**GEOLOGIC FEATURES AND THEIR
POTENTIAL EFFECTS ON CONTAMINANT
MIGRATION, SANTA SUSANA FIELD
LABORATORY**

Howard G. Wilshire, Ph.D.

October 5, 2006

ABSTRACT

Exhibit 1. Drawdown contours (in feet) from water extraction, 1954-1997 in the northeastern part of the SSFL. From L. P. Smith (Haley & Aldrich), Appendix B, Conceptual Site Model, Santa Susana Field Laboratory, Hydrogeology Summary Report (April 2000), Figure 1.9.

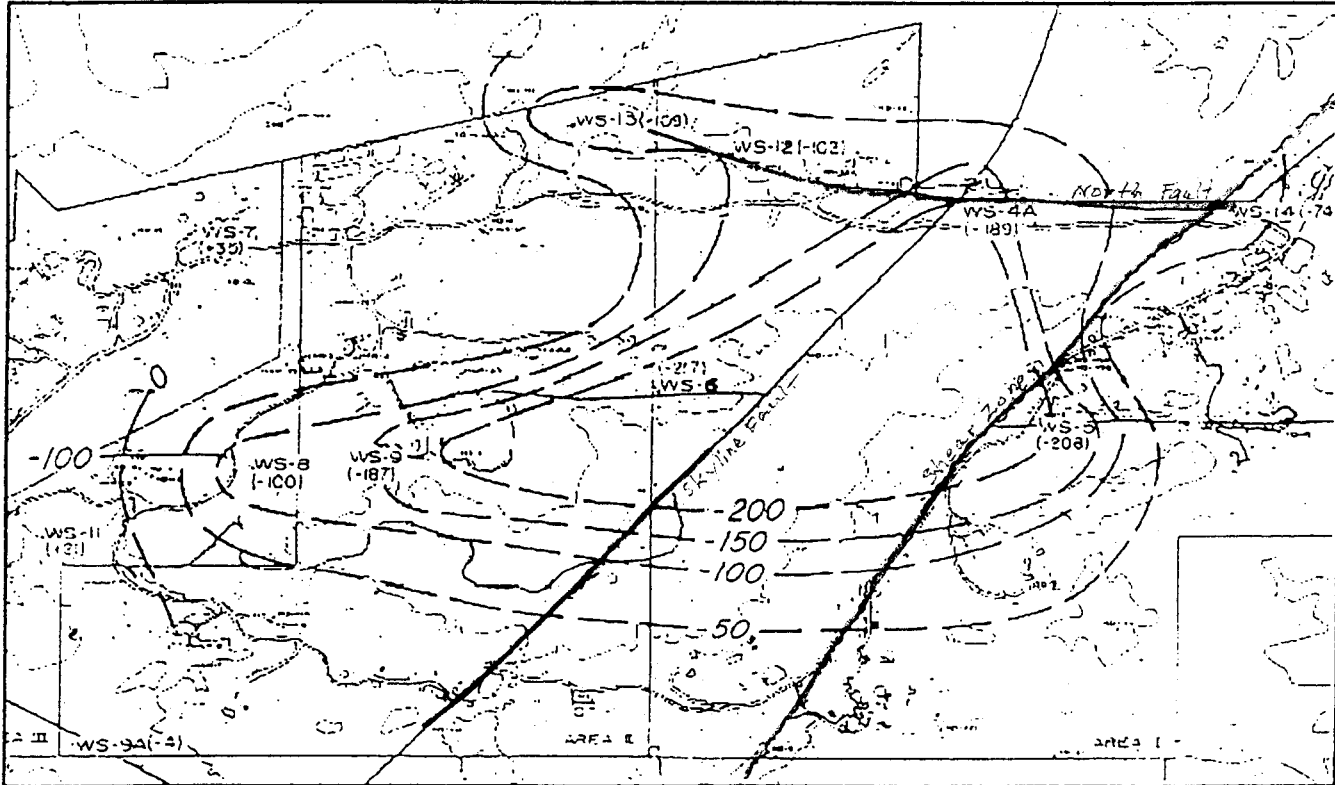
from the fault is not clear. Rates of response through the different kinds of fracture systems (clusters of steep fractures in the fault zone) and discontinuous, complex joint and stress fracture systems may cloud pump testing results. This is consistent with the behavior of wells WS-4A, WS-12, and WS-14 in the 1996 hydraulic communications study.⁷⁶ These wells did not respond immediately to shutdown of WS-6, but water levels in those wells (see Exhibit 3 for well locations) began to rise five to seven days later. This was true also of WS-13, but it could have been responding to RD-9 as well as WS-6. The drawdown pattern shown in Exhibit 1 also supports North Fault as a groundwater conduit.

Exhibit 2. Hydrographs, 1994-2001, for wells WS-5, RD-45A, RD-45B, and RD-45C. From MWH, Technical Memorandum, Geologic Characterization of the Eastern Portion of the Santa Susana Field Laboratory (February 2002), Figure 15. Note faults differ from current representations.

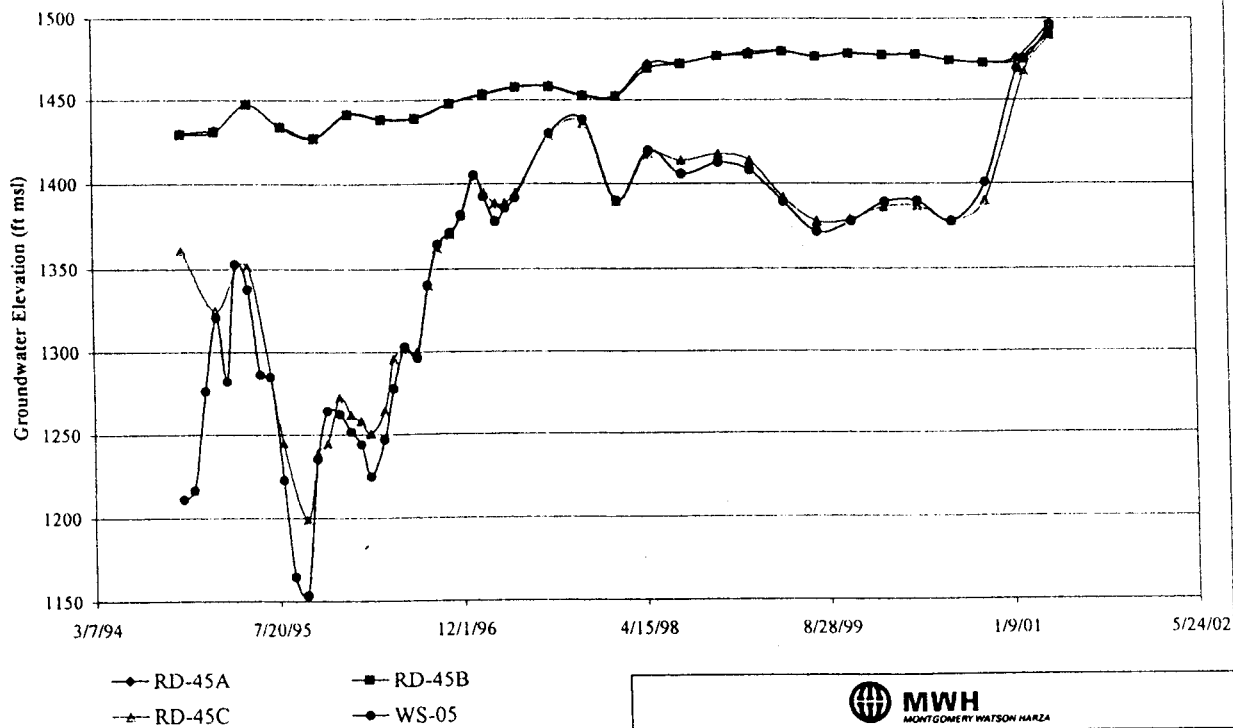
The RD-45 well cluster, now considered to be on the west side of the Shear Zone, shows an interesting response between 1994 and 2001 to shutdown and startup of pumping of well WS-5, on the east side of the Shear Zone. RD-45A is interpreted to be open from the Middle Sage Member across the Lower Line Bed into the Lower Sage Member, RD-45B is interpreted to be open only in the Lower Sage Member, and RD-45C is interpreted to be open within and below the Woolsey Member(?).⁶⁵ It should be noted that lithologic logs of these wells indicate that the Lower Line Bed is allowable in 45A and C, but not in B, and that identification of the Woolsey Member(?) is not allowable by the lithologic log of 45C, that is, the material logged at the appropriate depth in 45C does not resemble descriptions of the Woolsey Member. Other reports⁶⁶ identify this level of 45C as the Happy Valley Member, which also does not resemble the well log. Exhibit 2 shows the long-term hydrographs for wells WS-5 and the RD-45 cluster. RD-45C practically duplicates the water level pattern of WS-5, whereas RD-45A and B do not respond to shutdown or pumping of WS-5. It is noteworthy that shutdown of WS-5 in October

2000 resulted in a makeup of the 80 foot difference in water levels between RD-45A, B and RD-45C. Table 4 of the 1997 Hydraulic Communications report shows all three wells of the RD-45 cluster responding rapidly to well shutdown and restart, but hydrographs show that RD-45A and B are responding to well WS-6, whereas RD-45C is responding to well WS-5. This behavior is perplexing, but it is difficult to see how, at least at the screen level of RD-45C, the Shear Zone can be acting as an aquitard.

West of the Shear Zone, wells C3, RD-45A, and RD-45B are located within the Lower Sage Member, stratigraphically above the Woolsey Canyon Member. A section between 585 and 655 feet depth in RD-45C is tentatively interpreted to represent the Woolsey Canyon Member (note that this earlier was interpreted to represent the Happy Valley Member, but the log of RD-45C for that interval does not resemble descriptions of either the Woolsey Canyon or Happy Valley Members; identification of the Lower Sage Member in C3, RD-45A, and 45B also has difficulties because of uncertain location of the Lower Line Bed—see discussion of Shear Zone). The water level in RD-45C, thought to be open below the top of the Woolsey Canyon Member was at the time of the measurements about 80 feet lower than that of wells C3, RD-45A, and RD-45B.¹⁰⁴ As previously discussed, this difference was made up with the shutdown of WS-5 in 2000 (Exhibit 2).

Exhibit 3. Portion of SSFL, showing locations of wells WS-5, RD-73, RD-38A, B, and WS-14, and current locations of faults. From MWH, Near-Surface Groundwater Characterization Report, Santa Susana Field Laboratory (November 2003), Figure 2-9.

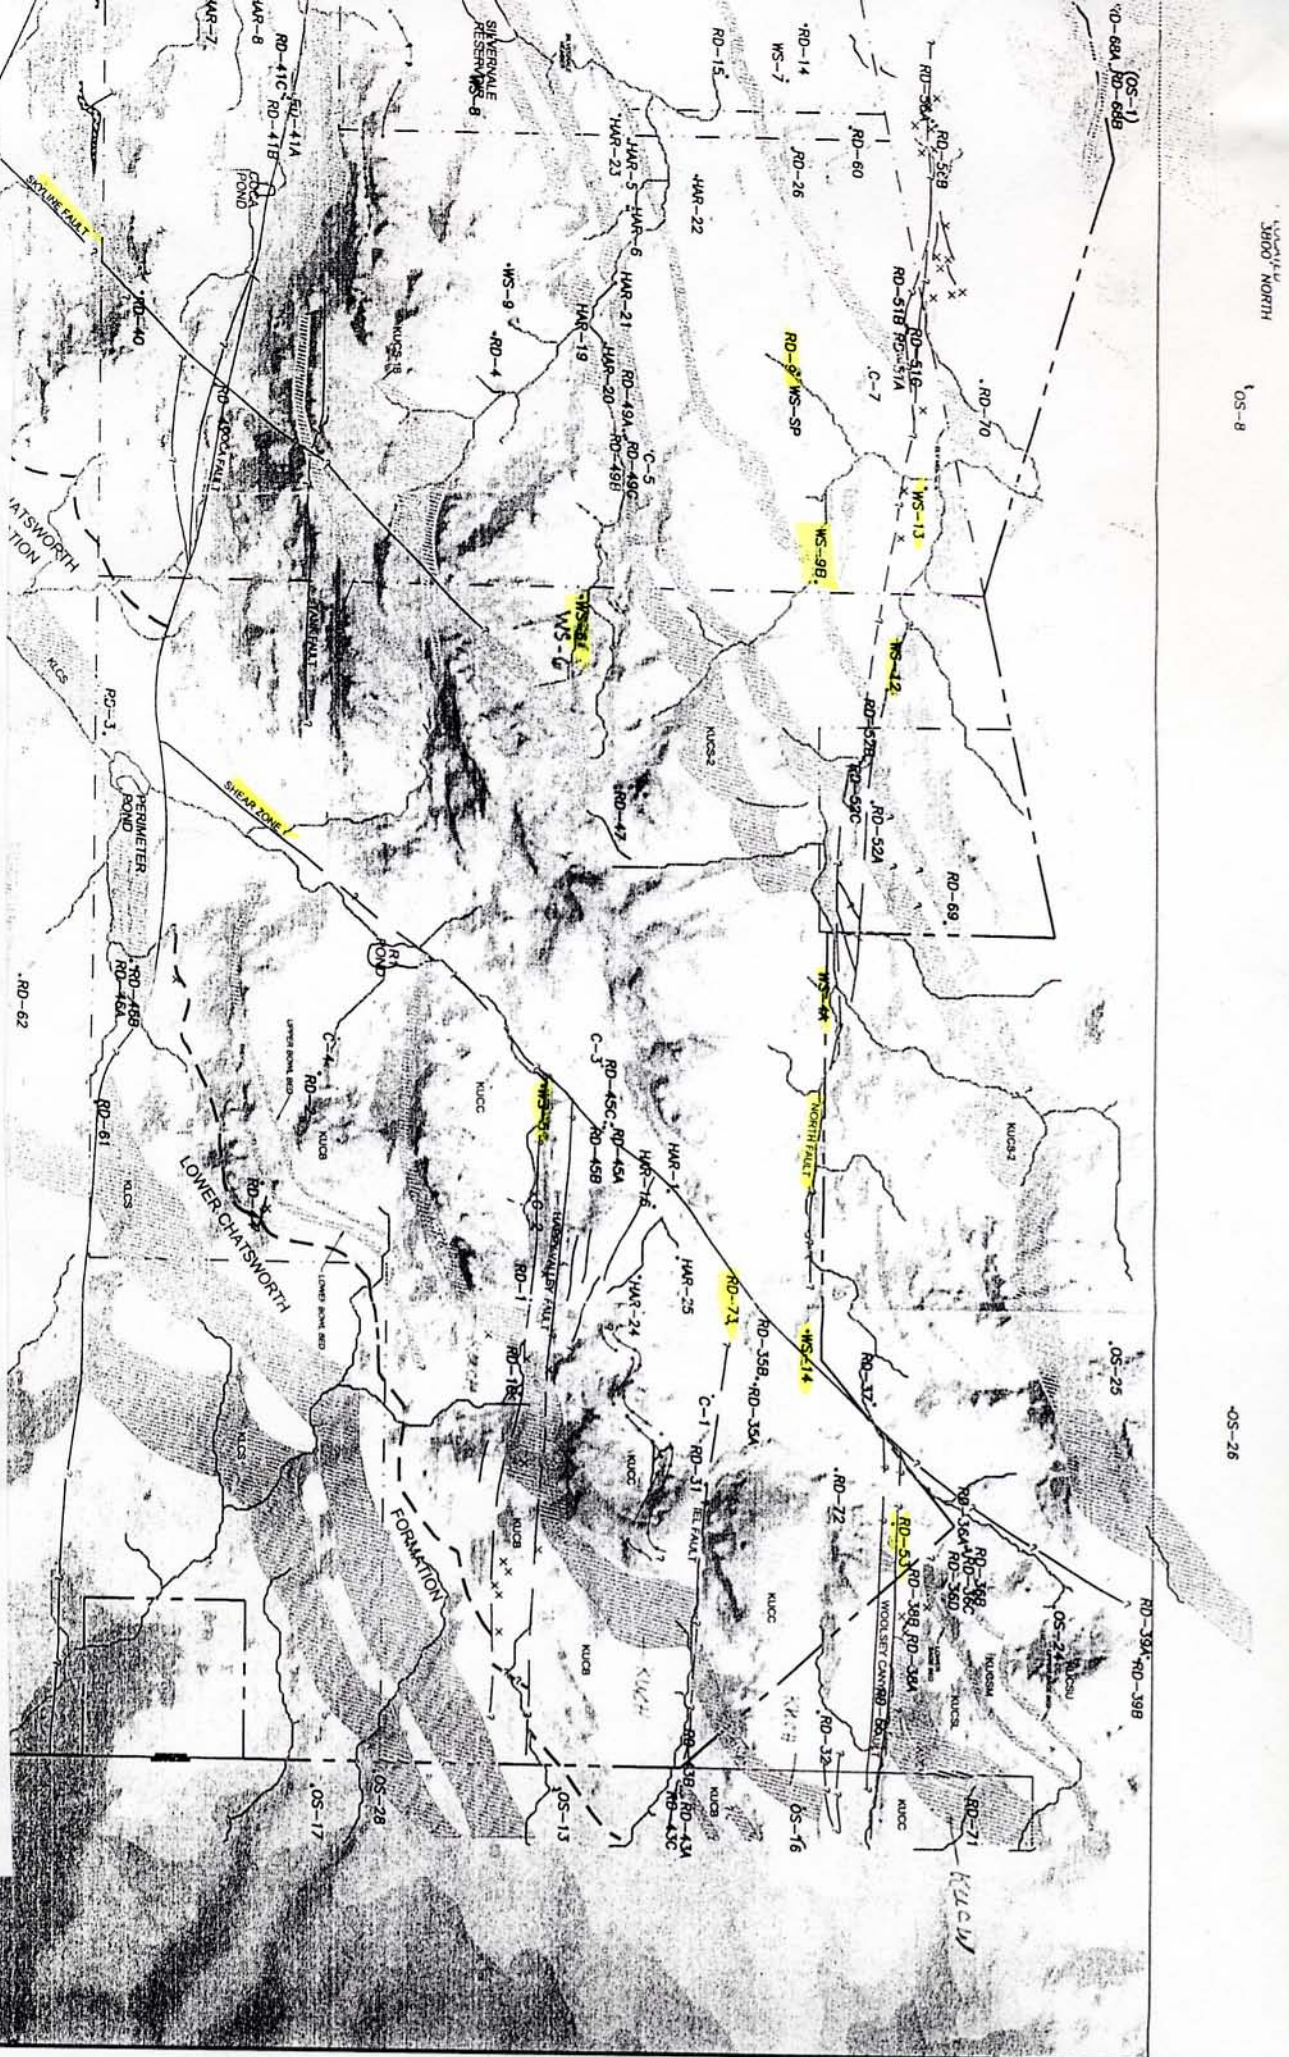
The lack of response of WS-14 to a 90-day pump test of RD-73, located on opposite sides of the Shear Zone is further taken as evidence that the Shear Zone is an aquitard.⁶⁷ This may well be the case, but until WS-14 is precisely located with respect to the full extent of the Shear Zone and RD-73 is precisely located with respect to the IEL Fault, this will remain uncertain. That conditions in the vicinity of WS-14 are complex is shown by the RD-38 cluster, which is closer to WS-14 than is RD-73. RD-38A did not respond to a pump test of the adjacent RD-38B (see Exhibit 3). This unexpected result is explained by the presence of a hypothetical gouge zone, which was not observed on video logs, between the two wells.⁶⁸ To compound the uncertainties, the log of RD-53, located in the Woolsey Canyon Fault Zone that separates RD-73 and the RD-38 cluster, does not mention any fault-related features.⁶⁹

Contours representing drawdown from the RD-73 pump test are shown in Exhibit 4. The contours are interpreted to indicate an apparent rise in hydraulic conductivity about parallel to strike of the Chatsworth Formation, and that "drawdown appears to truncate at the shear zone to the west, and at the Happy Valley Fault to the south."⁷⁰ This is based solely on the behavior of WS-14 (discussed in the previous paragraph) because no other wells west of the Shear Zone were monitored, and there is no control for designating the relationship of drawdown to the Happy Valley Fault. Representation of the contours as crossing the subsequently recognized IEL and Woolsey Canyon Faults without deflection does not prove that they are not aquitards, but rather there is no control for the location of the contours—that has not changed since the contours were drawn or the faults were mapped. A possible E-W fault passes very close to RD-72 and RD-32 between the Woolsey Canyon and IEL faults.⁷¹ The presence of a fault in this area is supported by the video log of RD-32,⁷² which logs a number of broken zones; a log of RD-72 is not yet available.

72. Among the problems with this interpretation is the lack of information of where RD-72 may be located with respect to a possible fault in close proximity to RD-72 (see Exhibit 4). In addition, RD-72 has a history of sporadic TCE detects, at times showing no contamination.⁸⁰ As shown in Exhibit 4, drawdown contours for a pump test of RD-73, and in Exhibit 5, water level contours for Groundwater Unit 1a as recognized in 2000, the contours pay no attention to faults, including the Woolsey Canyon Fault Zone, the IEL Fault, and the possible fault near RE-72, not recognized at that time. However, no new data that would discredit the interpretations represented by the contours have been made available subsequently. Thus, the role of the Woolsey Canyon Fault Zone as an aquitard is putative.

Representations of drawdown contours from a pump test of RD-73 (Exhibit 4) and of water levels in Groundwater Unit 1a (Exhibit 5) do not show any effect of the then-unrecognized IEL Fault, but no new data have been provided to show the contours to be wrong.

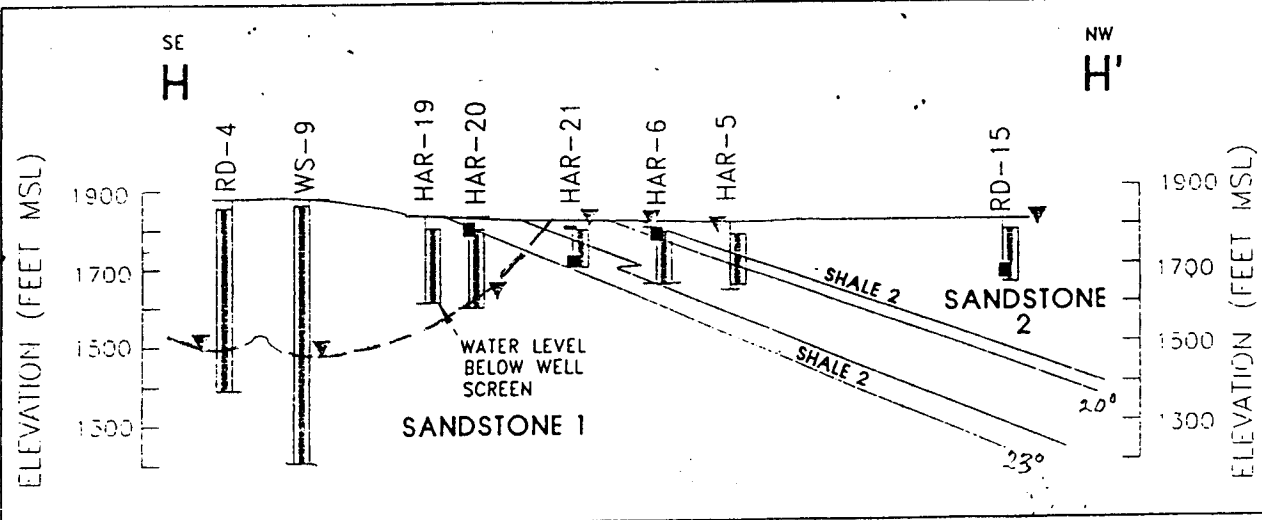
Exhibit 6 illustrates the case that Shale-2 acts as an aquitard between Sandstones-1 and -2 (old designations), as seen in water levels in wells RD-4, WS-9, HAR-19, and HAR-20 screened in Sandstone-1, and HAR-21, HAR-6, HAR-5, and RD-15 screened in Sandstone-2. Wells RD-4 and WS-9 are pumped wells with water levels governed by long-term extraction. Wells screened in Sandstone-2 are about 200 to 300 feet higher than those screened in Sandstone-1. It should be noted that the section in Exhibit 6 is viewed toward the south, contrary to normal practice.⁹⁵ The section does not position HAR-20 and HAR-21 consistently with the rather complex representation of Shale-2 in Fig. 2-9 of the Near-Surface Groundwater study. In addition, the well distribution is a shotgun pattern, but no information is given on how the wells were projected to the section line. It also is not clear why other wells in the area were not used to assess the water level differences—wells not used that might represent Sandstone-1 conditions include RD-49A, RD-49B, RD-49C, and C-5, and those that might represent Sandstone-2 conditions, but which were not used, include HAR-22, HAR-23, and RD-16.

An unassessed alternative to the interpretation that Shale-2 in this particular area is acting as an aquitard is shown by the dashed line drawn in on the section line of Exhibit 6. This is meant to indicate the possibility that the water levels in HAR-19 and HAR-20 are on the side of a drawdown cone produced by pumping of RD-4 and WS-9. The drawdown cone could intersect

the ground surface east of the wells screened in Sandstone-2 and thus not have affected their water levels.

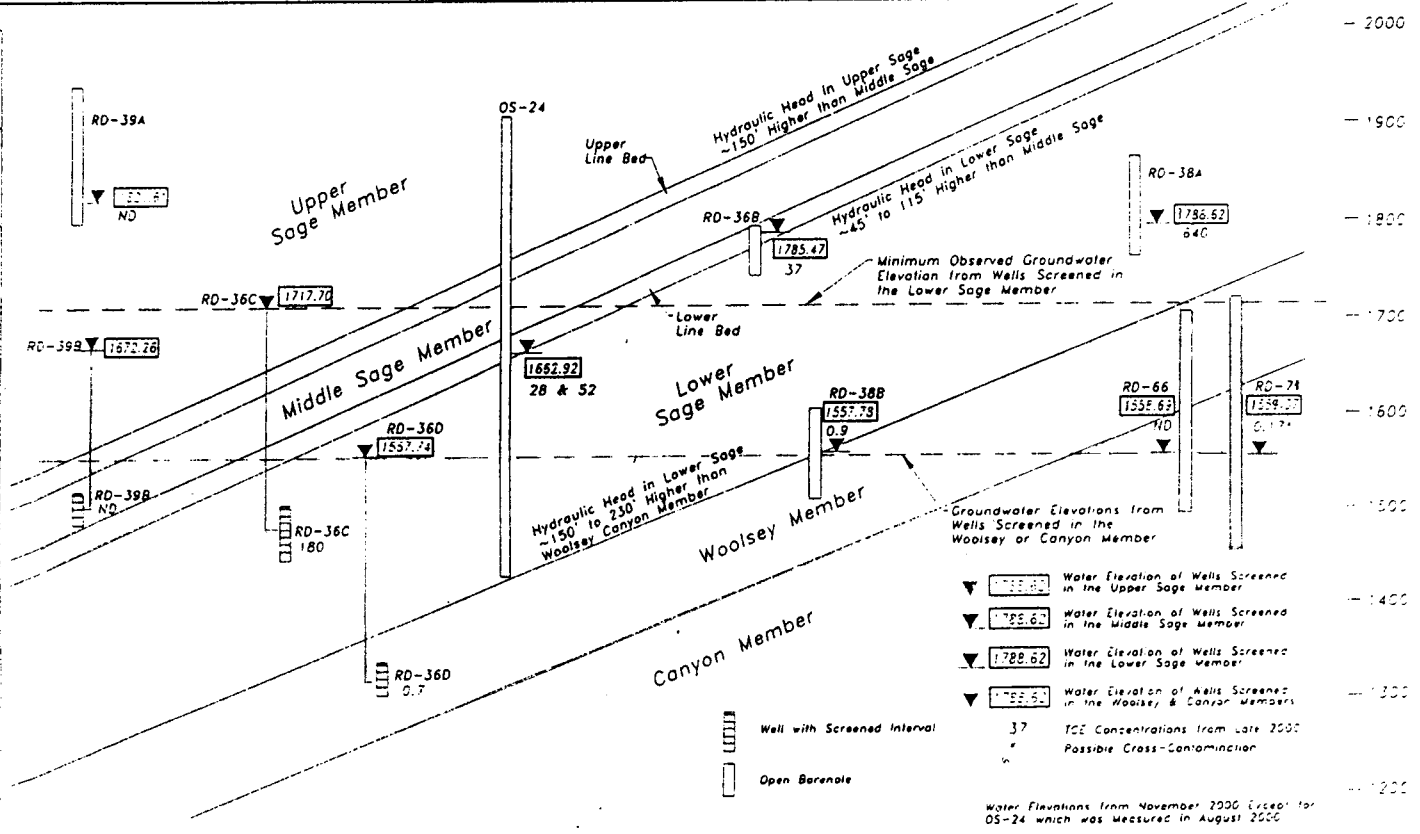
Support for the Upper Line Bed being an aquitard is found in the 150 foot difference in hydraulic head of RD-39A and RD-39B. RD-39A is screened solely in the Upper Sage Member and RD-39B solely in the Middle Sage Member. The Upper and Middle Sage Members are separated by the Upper Line Bed. A pump test of RD-39B did not affect the water level in RD-

39A, lending further support to the Upper Line Bed being an aquitard.¹⁰⁰ Since RD-39A is the only well screened solely in the Upper Sage, this provides only a very skimpy basis for assessing the broader role of the Upper Line Bed; moreover, there are only two wells, one periodically dry, screened solely in the Middle Sage (RD-39B and RD-36A). Because of the proximity of RD-39A and B to the Shear Zone, more confirmatory evidence is needed to assess the role of the Upper Line Bed. The pump test may or may not be significant, considering the similar behavior of RD-38A and RD-38B and the lack of tangible evidence of separation by an aquitard (described in connection with the Woolsey Canyon Fault Zone above), and the behavior of the Lower Line Bed described below.
